Municipal Planning Commission
Regular Meeting

February 8, 2024
4:00 PM

- 2024-MPC-03 : Upper Gilchrist RD Parcel #71-00050.000 - Comprehensive Development Plan

**2024-MPC-03 : UPPER GILCHRIST RD PARCEL #71-00050.000 - COMPREHENSIVE
 DEVELOPMENT PLAN**

**UPPER GILCHRIST
MT. VERNON, OHIO
PRELIMINARY PLAT**

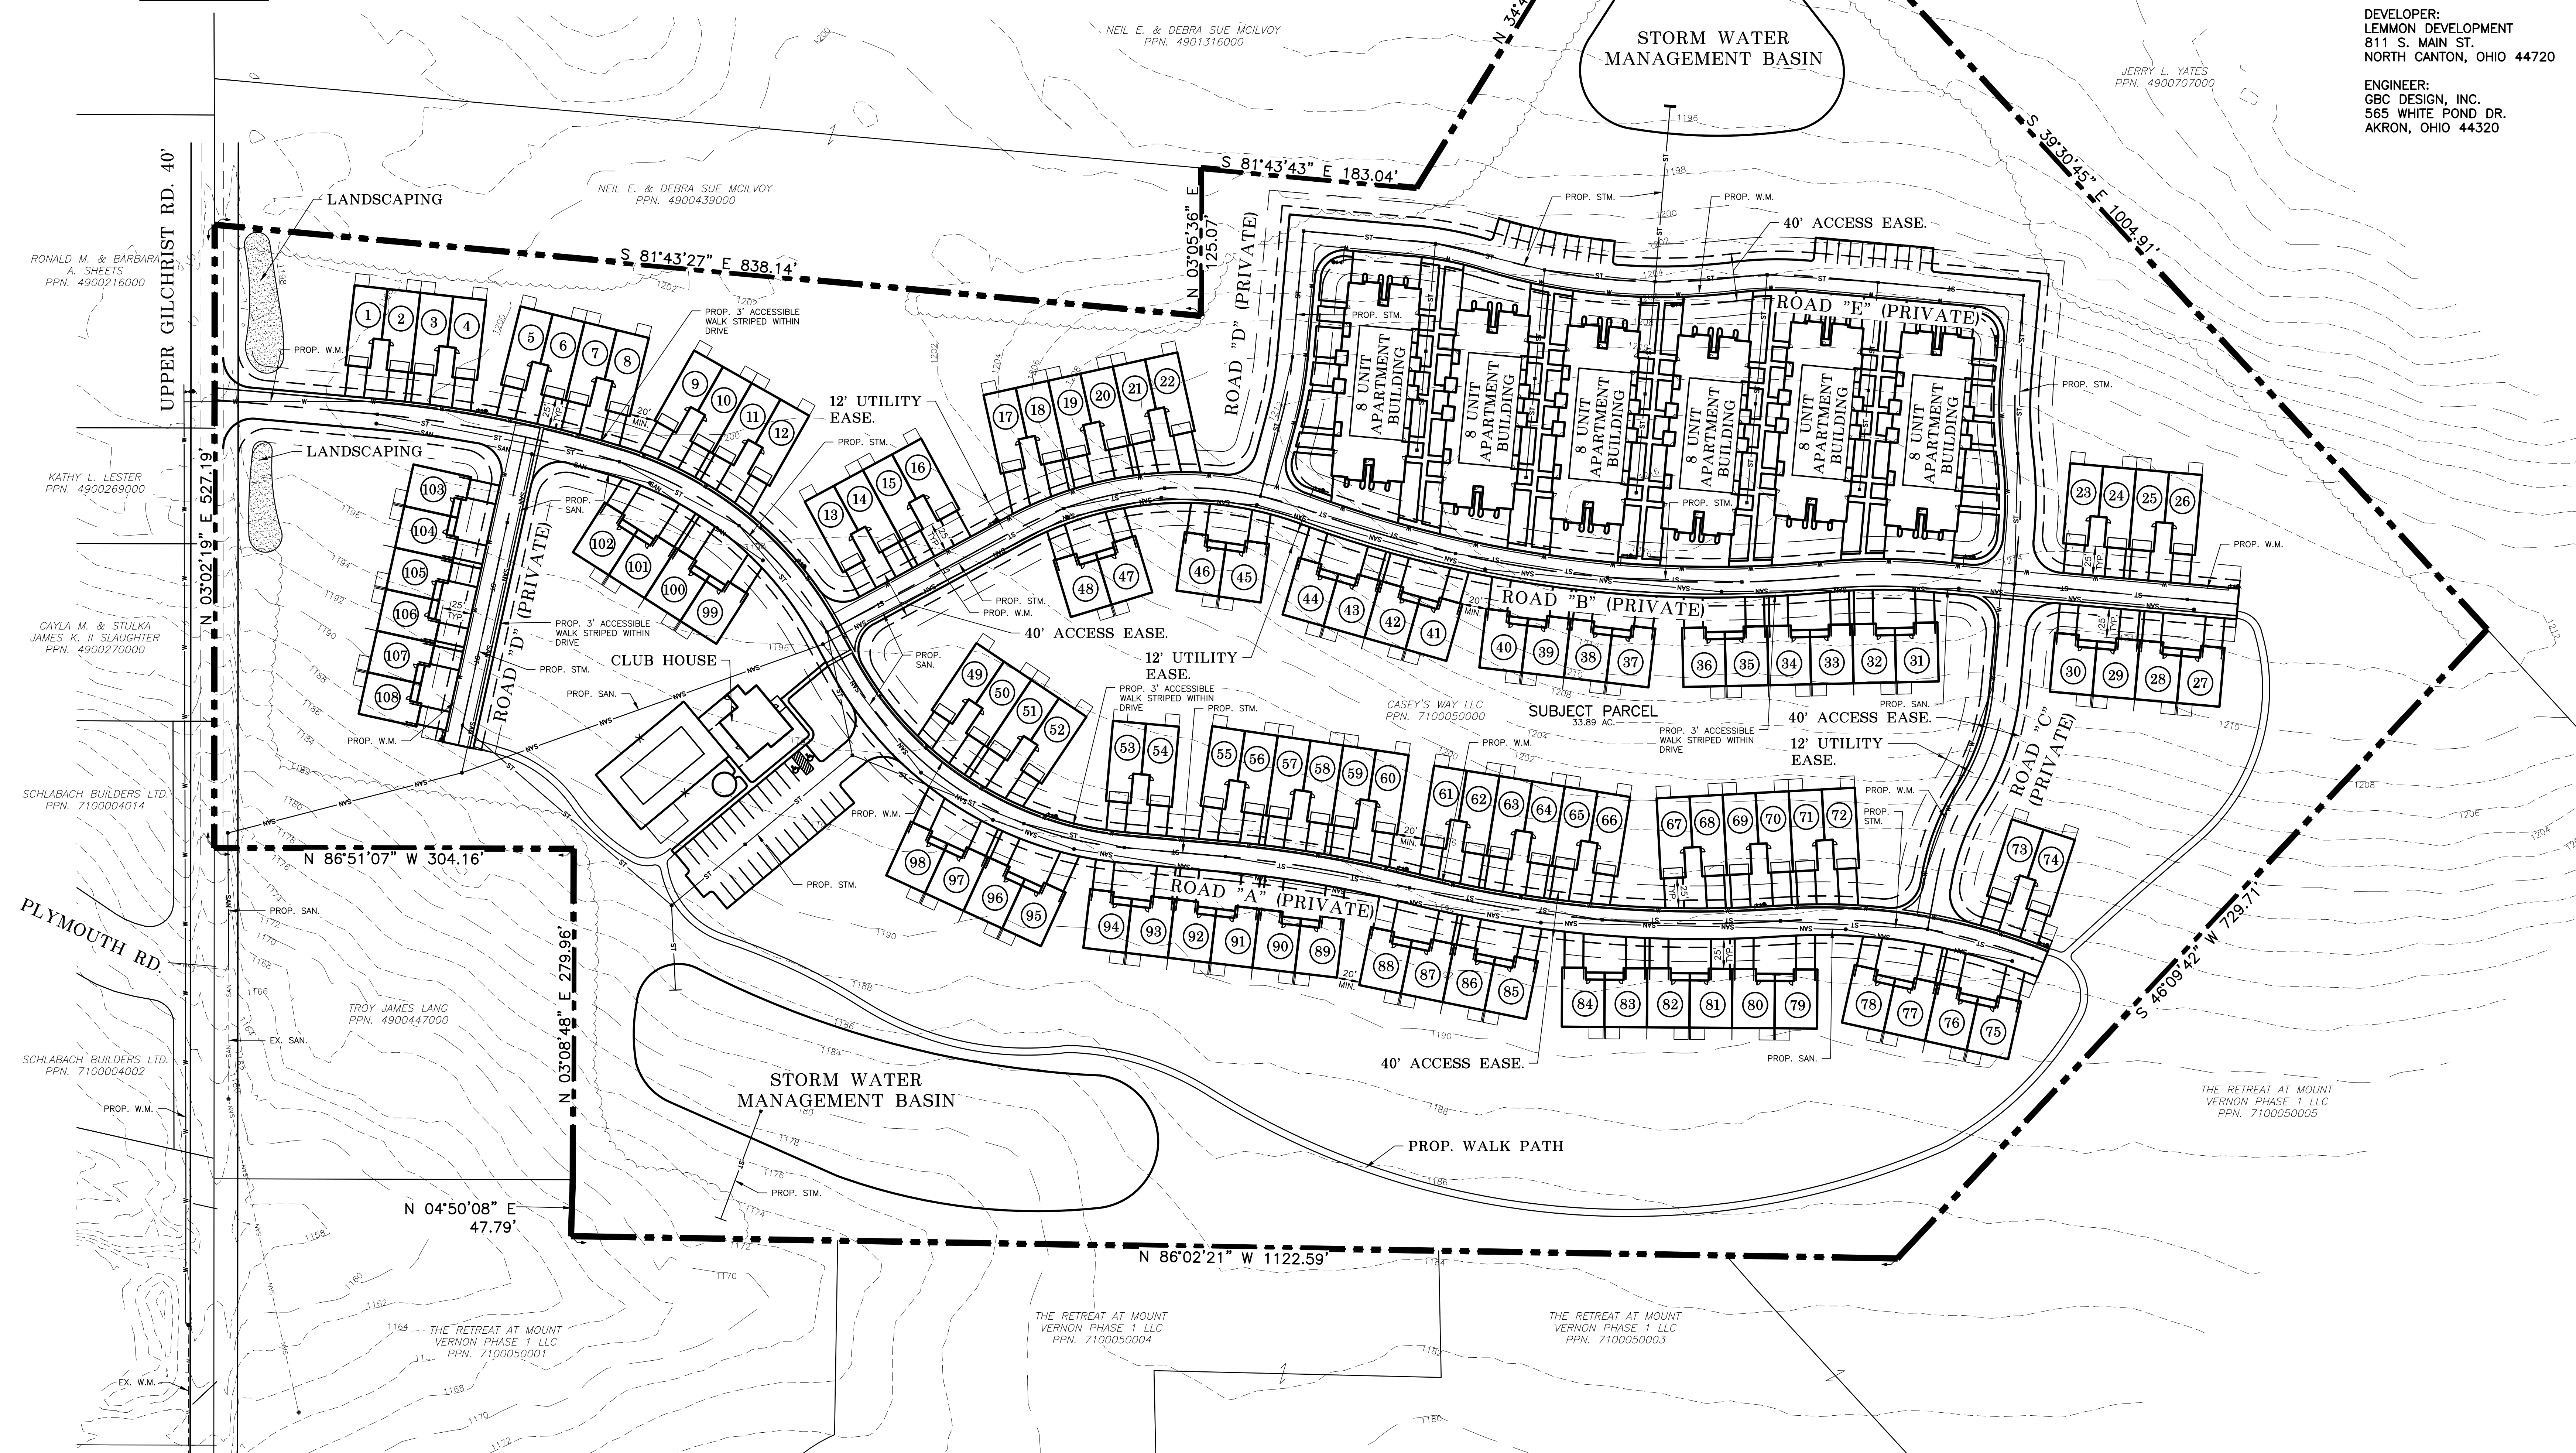
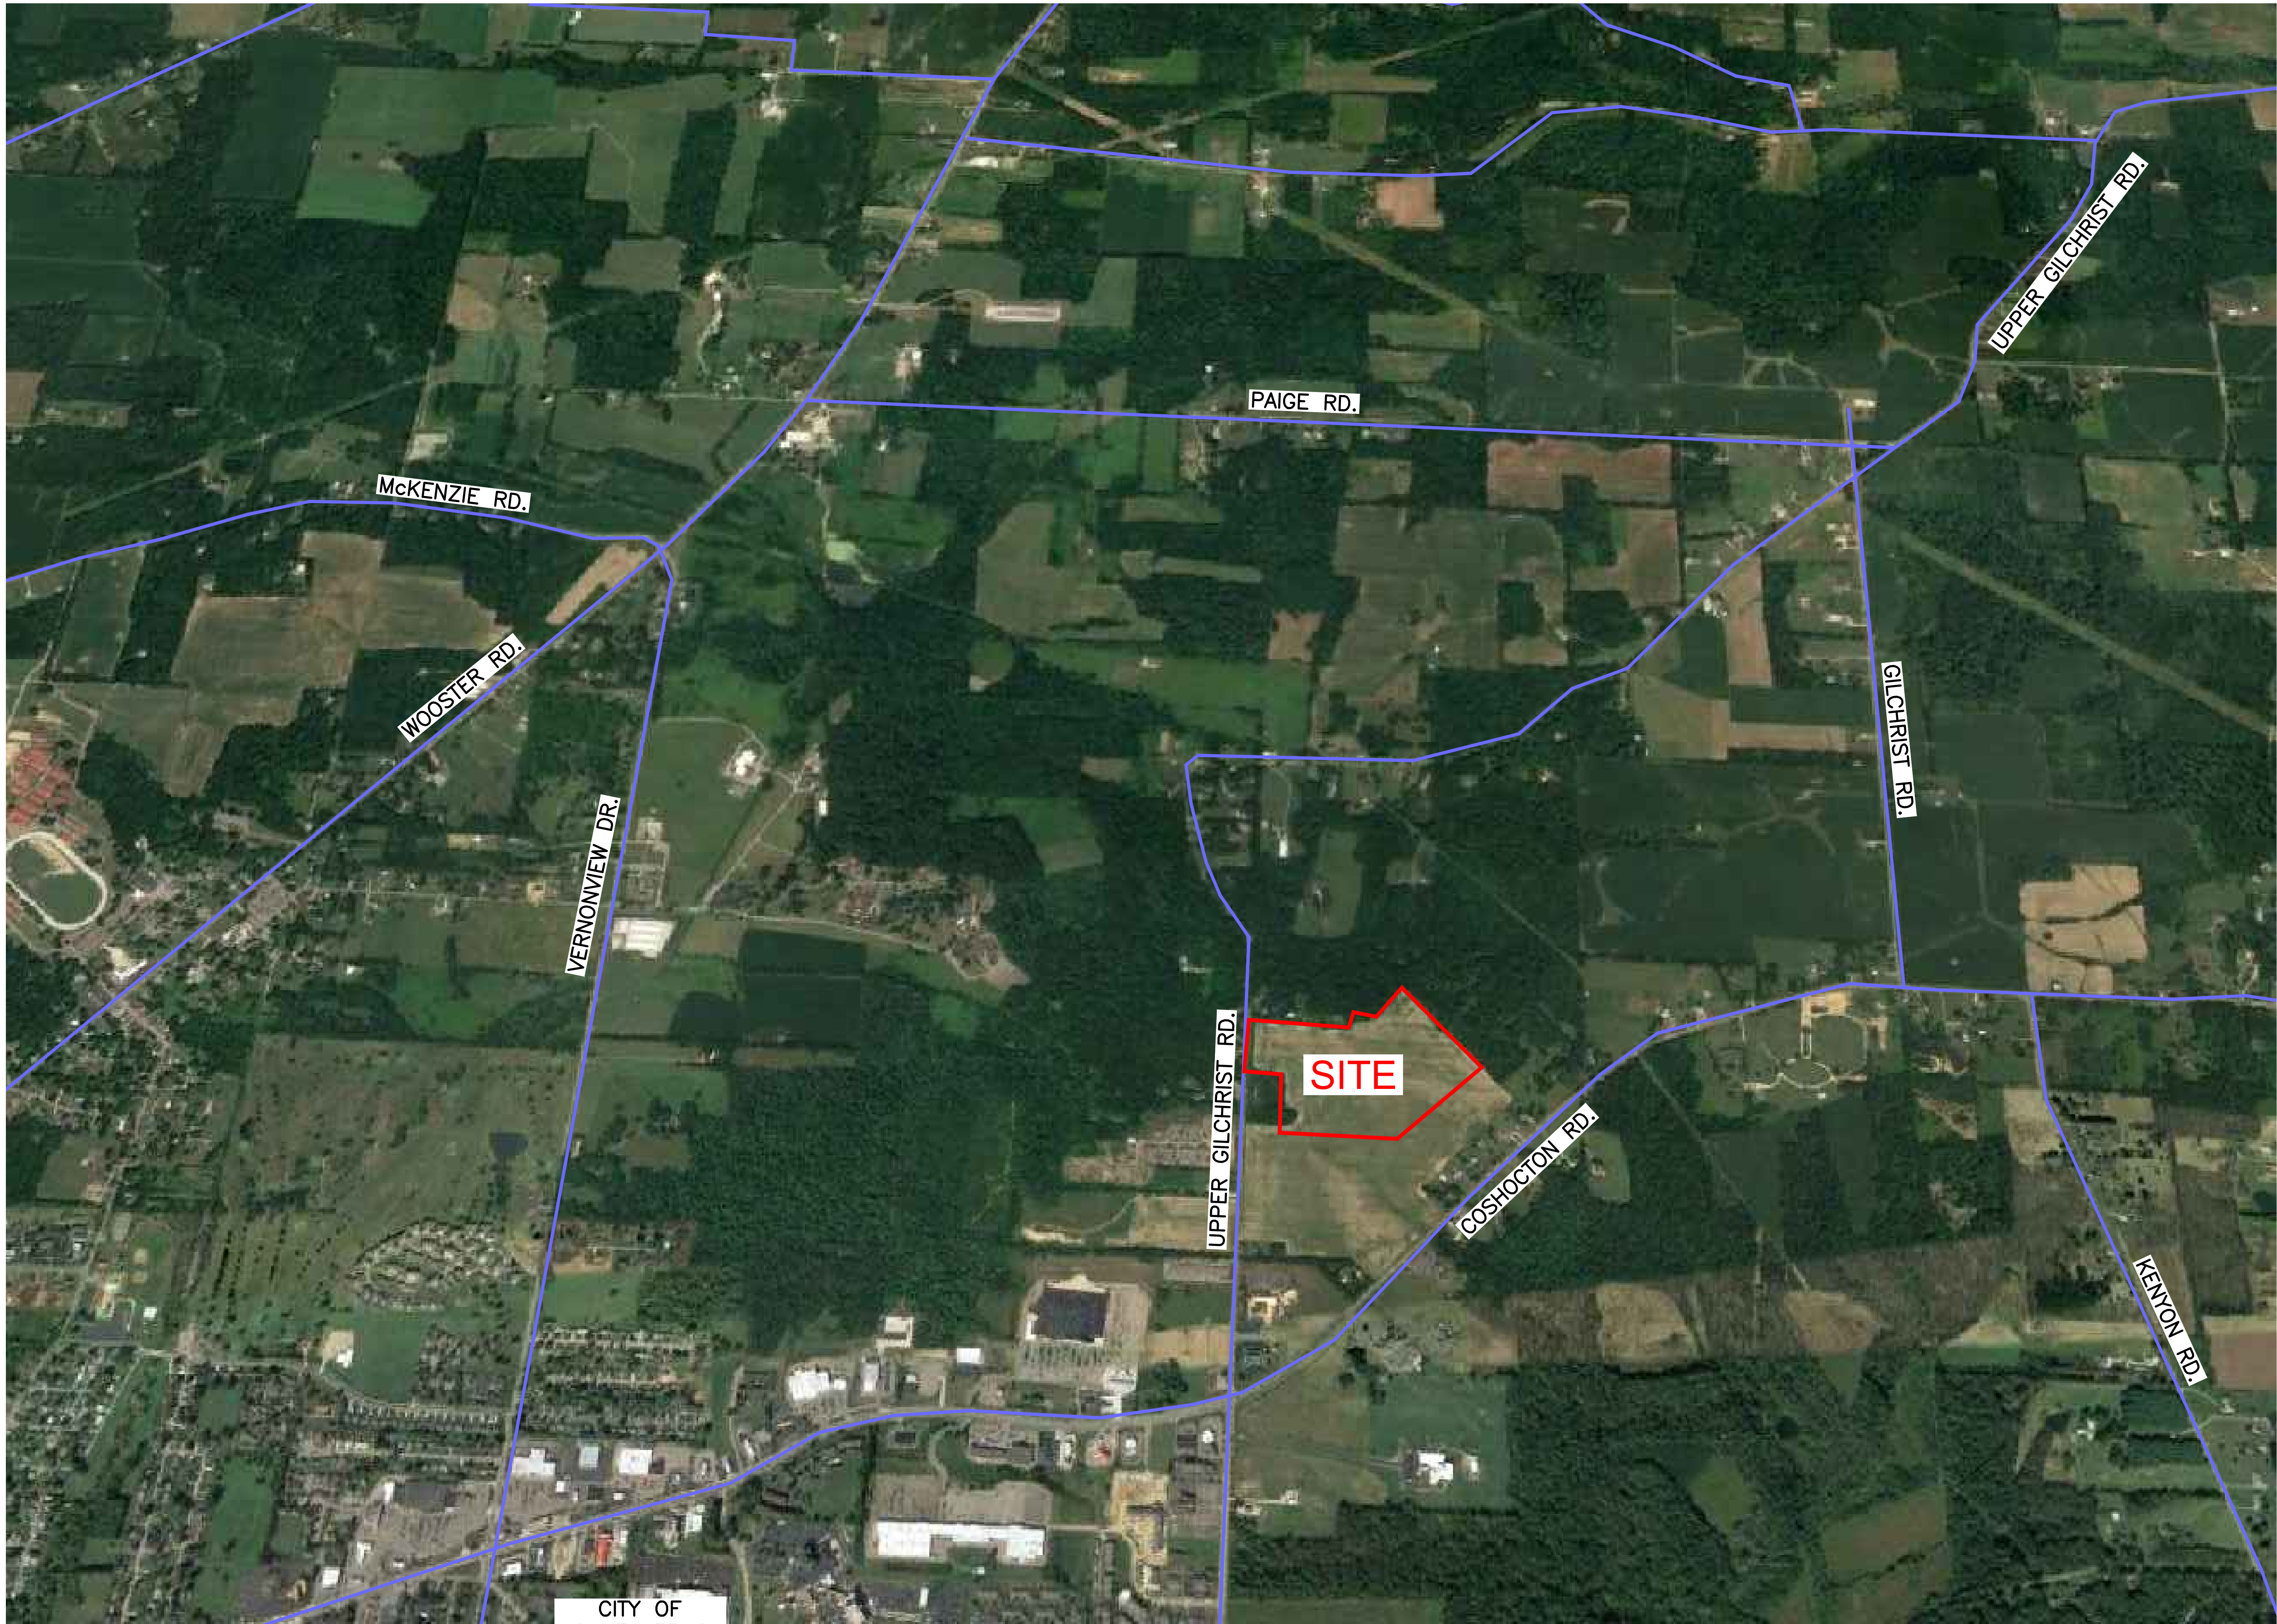
Blankenhorn drew attention to 2 near 90° corners on the north side Road D that don't appear to be conducive to driving patterns. Walsh said they would fill the square corners with a round corner. He said they have a program that will run a fire truck through and show how it tracks to make sure that it is accessible with the fire apparatus.

identified on the plan. Walsh said they would probably add that adjacent to the community center where the parking is.

Salyers asked if the roads would have curb and gutter. Walsh said he doesn't believe so, they will probably be an inverted pavement with a storm sewer going down through the middle. They are private and they will maintain them.

Broeren asked if they will not have a sidewalk. The plans say a 3' asphalt lane that is divided by a line. Walsh said that is correct. He was not certain that they have decided whether it will be asphalt and striped or whether it will be an actual concrete. He said it meets the ADA guidelines as far as providing accessible routes into the buildings. Broeren said there has been an increase in pedestrian/car deaths. He is concerned with having the pedestrians on the same level with the cars without any separation. A yellow line striped on the asphalt is probably not going to provide a lot of protection, especially in a community that is aimed at 55 and older. He wonders if it might be better to do concrete sidewalks to get the people up off the road. Walsh said they would be willing to look at that and see if that will work.

Starr said the street names and the name of the subdivision are not identified, which is required. Mackie said they have a vetting process to come up with names. There are several possibilities in the works. Walsh asked if there is a 9-1-1 requirement, assuming a name can't be duplicated in the City. He asked if that also applies to the County. Salyers said there are duplicate names in the County. Ball said we prefer not to. He said this property is technically in the County and in the City because of the Type-2 annexation. His suggestion is to not duplicate a name.

Starr asked about identifying building setback lines. Walsh said they are on there, but they are probably not called out. The goal is to have a 25' minimum driveway length, from the edge of pavement to the front of the garage. Broeren said 25 TYP is on the noted on the drawing, but the actual setback is not provided. Walsh asked if the City would like them to add that. Blankenhorn said that is one of the items included on the preliminary plat checklist.

Starr asked Blankenhorn to explain what no profiles or cross sections meant, as noted on her staff report. Blankenhorn said that is part of the preliminary plat checklist that is included in City Code. Profiles and cross sections are required to be provided for the streets, sanitary sewer, and waterlines. Walsh said the water and sewer can be added. He asked the City Engineer if cross sections are more typical for a City street or do you not differentiate. Ball said the sewer can't be private. Water may be public or private. Ball asked if we were doing plat and development plan or just development plan. Blankenhorn said one of the requirements of the Comprehensive Development Plan is a Preliminary Plat conforming to the subdivision regulations and including at least 20% of the total acreage included in the Comprehensive Development Plan. Walsh asked if they do not go through the Preliminary Plan process, it is rolled into the Comprehensive Plan, as a requirement. Ball said there is a plan and a plat. Blankenhorn said they have submitted for a Comprehensive Development Plan. Part of the requirements for that is a Preliminary Plat. There is a checklist for the Preliminary Plat and not all of the items are addressed with the submittal. Walsh said those items can be added.

Stulka (sworn in) asked where this developments entrance aligns on Upper Gilchrist Road. The plan image was displayed and zoomed in on the TV display for Stulka to view (drawn to be located across from the shared property line of the Sheets and Lester properties). Ball added
